TOLEDO - LUCAS COUNTY PLAN COMMISSIONS

REF: SUP-12003-22

SUBJECT: Amendment to a Special Use Permit Originally Granted by Ordinance 524-85, and Ordinance 852-86 for the raze and rebuild of a gas station and canopy at 950 W Alexis Rd.

SITE PLAN

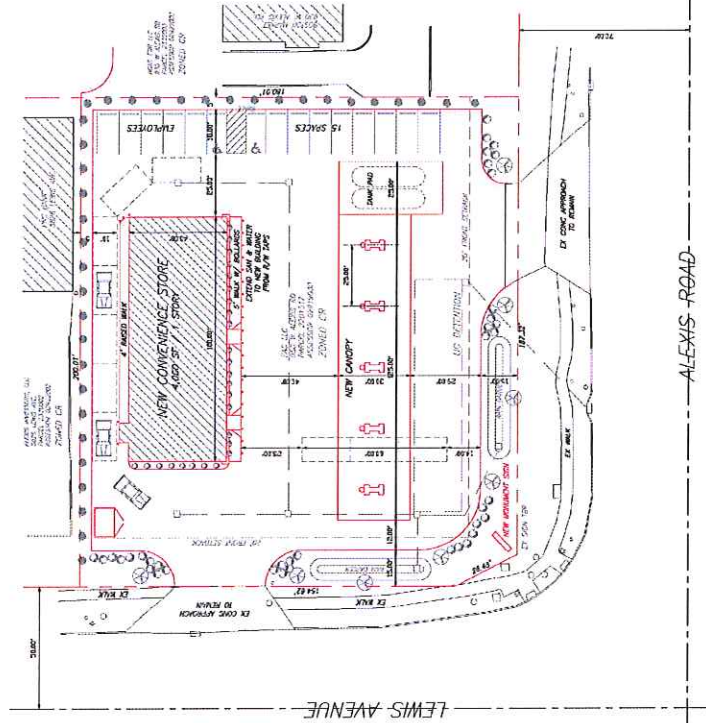
The site is required to have a minimum of one (1) stacking space per gasoline pump island, which have been provided. The drive-thru is required to have seven (7) stacking spaces per TMC§1107.1601 – *Vehicle Stacking Area*. The site plan provides the appropriate quantity of stacking. Bicycle parking is required at a rate of one (1) per ten parking spaces. None are shown and shall be required on a revised site plan.

The site is required to provide safe flow per pedestrian use per 1109.0204. A revised site plan shall be required to depict at least one walkway connecting the sidewalk going along either Alexis or Lewis to the front door of the building.

29. At least one (1) van accessible parking space shall be provided (TMC§1107.1701). **Acceptable as depicted.**
30. Any spaces reserved for the use by persons with physical disabilities shall adhere to the standards outlined in TMC§1107.1700.

33. Litter receptacles for the use of parking area users and others, must be provided in off-street parking areas per TMC§1107.1910.
34. Pedestrian connectivity from the sidewalk on Alexis or Lewis shall be provided to the primary entrance.

39. The minimum number of parking spaces for this site as indicated in TMC§1107.0300 – Off-street parking schedule “A” is twenty (20), including parking spaces at gas pumps. The site plan indicates twenty-five (25) parking spaces. **Acceptable as depicted.**

40. Bicycle parking shall be placed within proximity to the primary entrance of the building to allow for safe use of the facility for cyclists entering the site from either frontage. A minimum of three (3) bicycle parking spaces are required. **Acceptable as depicted.**

LANDSCAPE PLAN

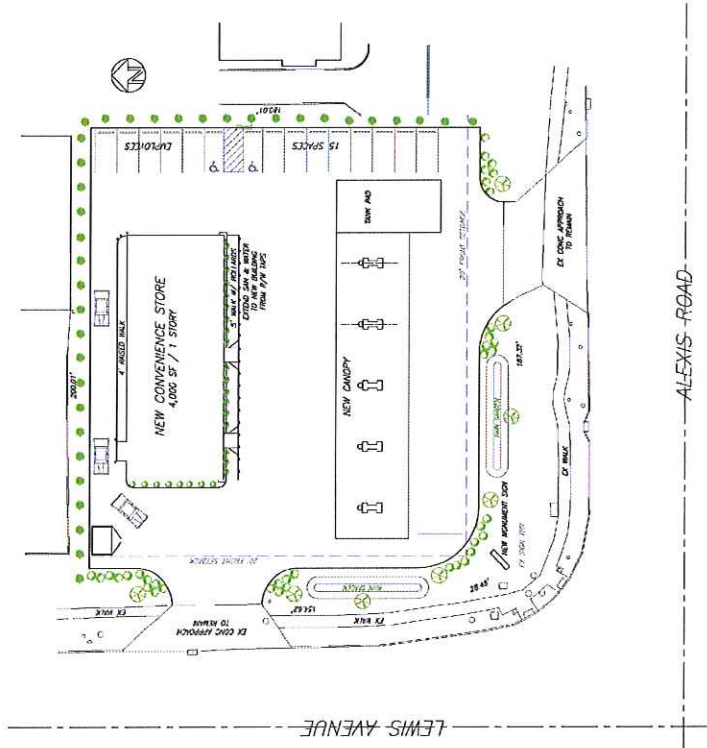
Pursuant to TMC§1108.0202 – *Frontage Greenbelt*, the site is required to have a fifteen-foot (15') planted landscape buffer along all street frontages. The buffer must contain at least one (1) tree for every thirty feet (30') of frontage. When a parking lot is proposed along the frontage greenbelt, there shall also be a solid evergreen hedge to screen the parking lot so that no headlights of any vehicles can be seen from the public street. A greenbelt is provided along Alexis and Lewis: as depicted it does not include all required plantings. In order to meet the requirement of one tree for every 30 feet (30') of frontage, seven (7) total trees shall be required along Alexis Road (four (4) are shown), and six (6) total trees along Lewis Avenue (four (4) are shown). A continuous line of shrubs is provided along the site, however gaps exist where the proposed rain gardens are located. The shrub line shall be required to be brought all the way along the parking area, and cannot be located within the rain garden. Corrections shall be shown on a revised landscape plan.

landscaping meets this requirement. Landscape terminal islands must be provided at the end of each parking row, none are depicted and shall be required in a revised landscape plan. Additionally, two (2) canopy trees and six (6) shrubs are required to be installed in interior landscape areas for each ten (10) parking spaces. A total of seven (7) trees and twenty-one (21) shrubs are required in the interior, which have been provided in the landscape plan.

Two (2) rain gardens are proposed within the frontage greenbelt. Said rain gardens may occupy up to 50% of the actual available greenspace, and are permissible as depicted. The stormwater treatment facility must be planted and landscaped, and may not reduce the other landscaping requirements provided within the TMC. The rain gardens must be planted with turf, trees, and/or perennial plant materials chosen from lists provided by the Rain Garden Initiative. The design of said rain gardens must be approved by the Department of Public Utilities. A revised landscape plan depicting the plantings within the rain gardens shall be submitted to the Plan Director for approval.

- a. A fifteen (15') foot landscape buffer along Lewis is required containing six (6) trees. **Not acceptable as depicted, additional trees required.**

- b. A fifteen (15') foot landscape buffer along Alexis is required containing seven (7) trees. **Not acceptable as depicted, additional trees required.**

- c. Perimeter landscaping is required around the parking lot to screen headlights from right of way. Additional shrubs stretching the entire length of the paved area along Lewis and Alexis are required. **Not acceptable as depicted.**

- f. Landscape islands/peninsulas are required at the end of each parking row. **None depicted, not acceptable as depicted.**
 - g. Landscape areas within the parking area must be peninsular or island types and must be constructed with six-inch (6") by eighteen-inch (18") concrete curbing, cast-in-place, extruded, or by some other process approved by the Planning Director;

- t. A detailed planting plan for the proposed rain gardens is required. The rain gardens must be planted with turf, trees, and/or perennial plant materials chosen from lists provided by the Rain Garden Initiative. The design of said rain gardens must be approved by the Department of Public Utilities. **No planting plan submitted.**
